VSP-33
December 18, 1981

VENDOR SERVICE PUBLICATION

To: All Piper Distributors and CORPAC's
Subject: Bendix Service Bulletins 611, 616, 617, 619

Part 1. Addition of moisture drains and sealing of vent screens in S-1200 Series Magneto Covers.

Figure 1. Location of Drain Holes

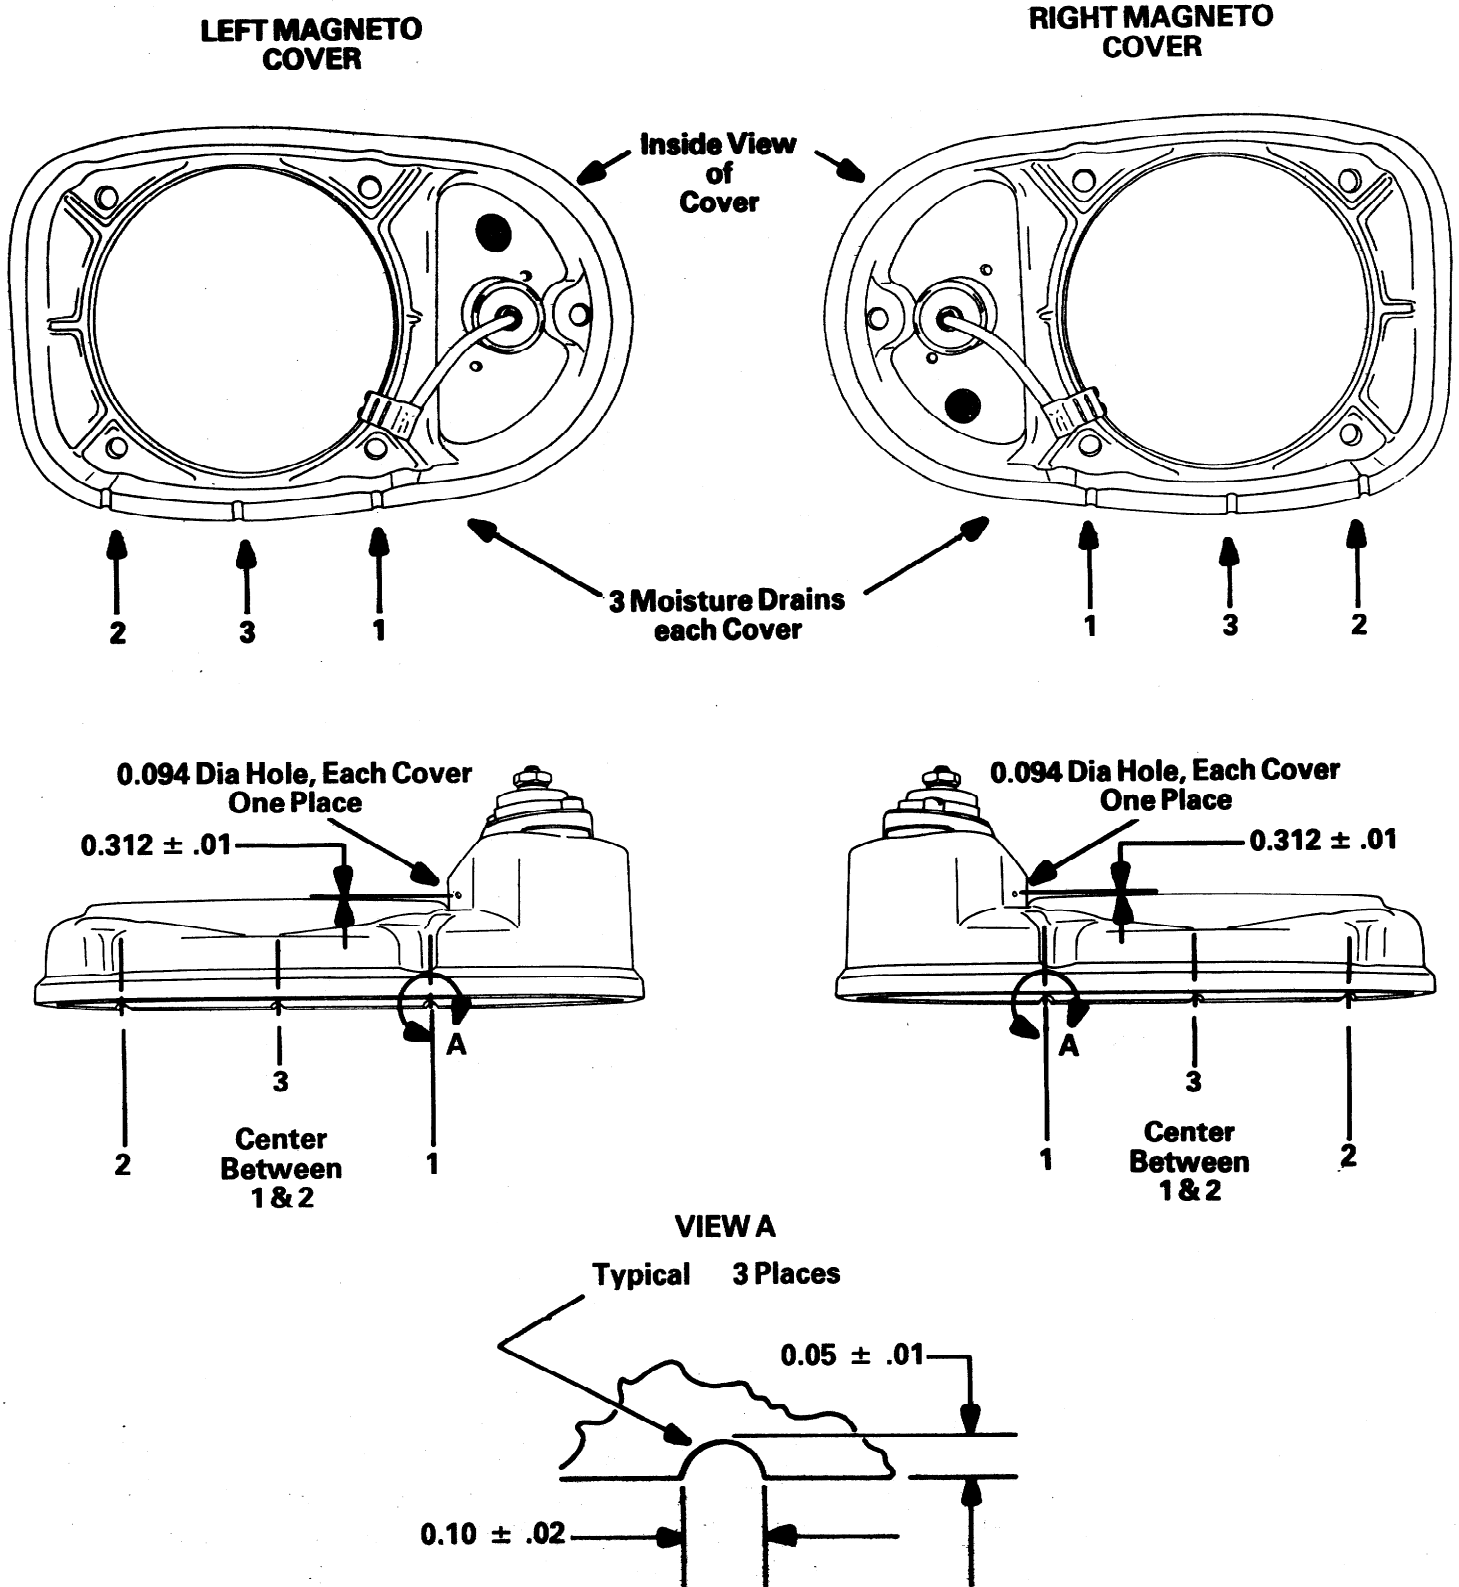
1. Remove the magneto cover by removing the ignition harness adapter plate from each magneto and then removing the magneto cover securing screw. Pull the magneto cover away from the magneto and carefully pull the capacitor, and retard lead, if used, from the breaker flag terminal(s).
2. Using Figure 1 as a guide, lay out the positions for the moisture drains. Positions 1 and 2 are in line with the stud holes in the cover and position 3 is centered between 1 and 2. Using a small round file, create the three hemispherical recesses as detailed in view A, figure 1.

The moisture drains must be on the lower side of each cover when it is reinstalled on its related magneto assembly on the engine.

3. Lay out the position for drilling a 0.094 in. $\pm$ 0.005 in. hole in the center of the ledge area of the covers and drill one hole in each cover using a 3/32" or No. 42 drill, as shown in Figure 1.

Do not allow the drill to penetrate through the cover and hit the housing of the capacitor which is directly in line with the hole being drilled. Mask drill bit for maximum allowable depth (1/4 in.).

Figure 1. Exploded View

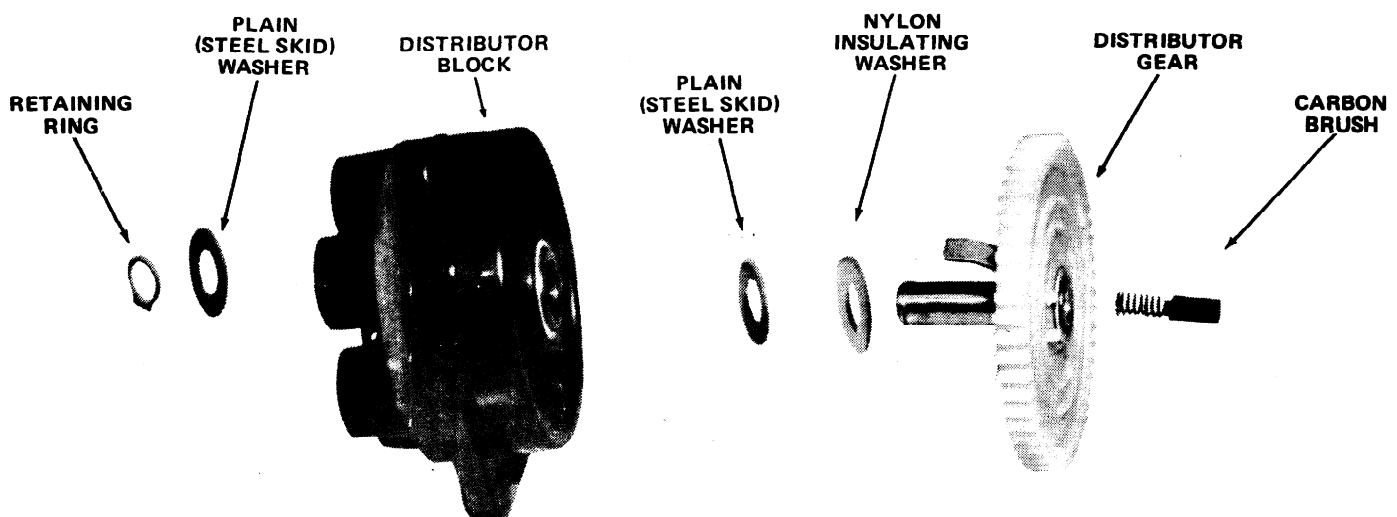
The 10-357584 and 10-357586 Insulated Distributor Gear Kits for S-20 and S-200 Series Magnetos are being provided as a standardization change for Bendix magnetos. With the introduction of these kits, all new Bendix aircraft magnetos delivered from the factory will be provided with insulated distributor gears. The insulated gear kits include all parts (except distributor block) as identified in figure 1.

Assembly sequence of the gear kit to distributor block is shown in the exploded view of figure 1.

Figure 1. Location of "x" on Identification Plate

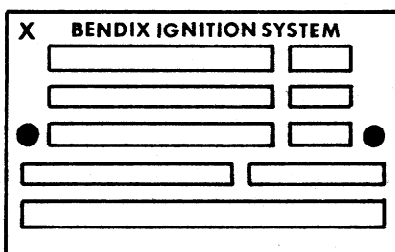
All D-2000/2200 series magnetos below serial number 35480 (red label magnetos) and below serial number 8122106 (blue label magnetos) unless identified with an "x" in the upper left corner of the identification plate before the word "Bendix" (see figure 1). The "x" on the identification plate indicates previous compliance.

6. If new serviceable gears, identified with the "z", the "x" and "o", or the "L" are installed in the magneto, identify the magneto by stamping the letter "x" in the upper left corner of the identification plate, before the word "Bendix" (see figure 1).

Figure 2. Location of Identification Mark(s)
on Distributor Gear

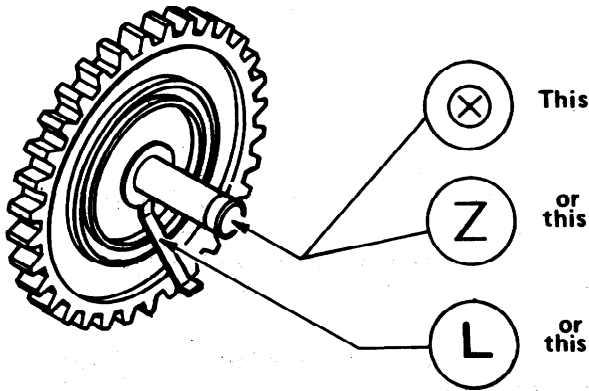
hours or at the next regularly scheduled inspection, whichever occurs first, and reinspected every 100 operating hours until the magneto has 500 operating hours. If the gears fail the inspection they must be replaced immediately with new, serviceable gears; if they pass each inspection they may remain in service until magneto overhaul, at which time they must be replaced with new, serviceable gears. At owner's option, gears that pass inspection may be replaced at any time during the compliance period with new, serviceable gears as identified in this paragraph and figure 2. Serviceable gears are identified by the presence of the letter "z" or the letters "x" and "o" appearing together, laser etched on the retaining ring end of the gear axle, or the letter "L" stamped on the electrode (see figure 2).

Figure 1. Location of "x" on Identification Plate

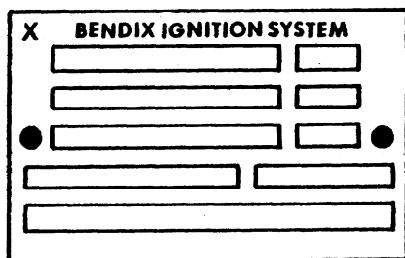
All D-3000/3200 Series (blue) Magnetos with Serial Numbers 100 through 1968 not identified by the letter "x" in the upper left corner of the identification plate (see figure 1). The "x" on the identification plate indicates previous compliance.

7. After the magneto has been reassembled with new serviceable gears, identify the magneto by stamping the letter "x" in the upper left corner of the identification plate, before the word "Bendix" (see figure 1).

Figure 2. Location of Identification Mark(s)
on Distributor Gear

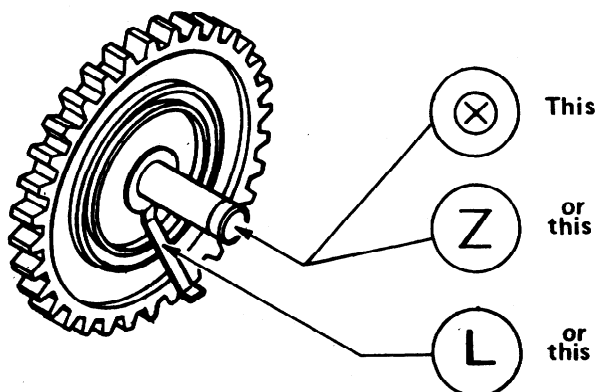
All distributor gear kits P/N 10-682014 and P/N 10-682016 which contain gears that are not identified by the presence of the letter "z" or the letters "x" and "o" together, laser etched on the retaining ring end of the gear axle, or the letter "L" stamped on the electrode (see figure 2).

5. Reassemble the distributor block with new serviceable gears. Serviceable gears are identified by the presence of the letter "z" or the letters "x" and "o" together, laser etched on the retaining ring end of the gear axle, or the letter "L" stamped on the electrode (see figure 2).
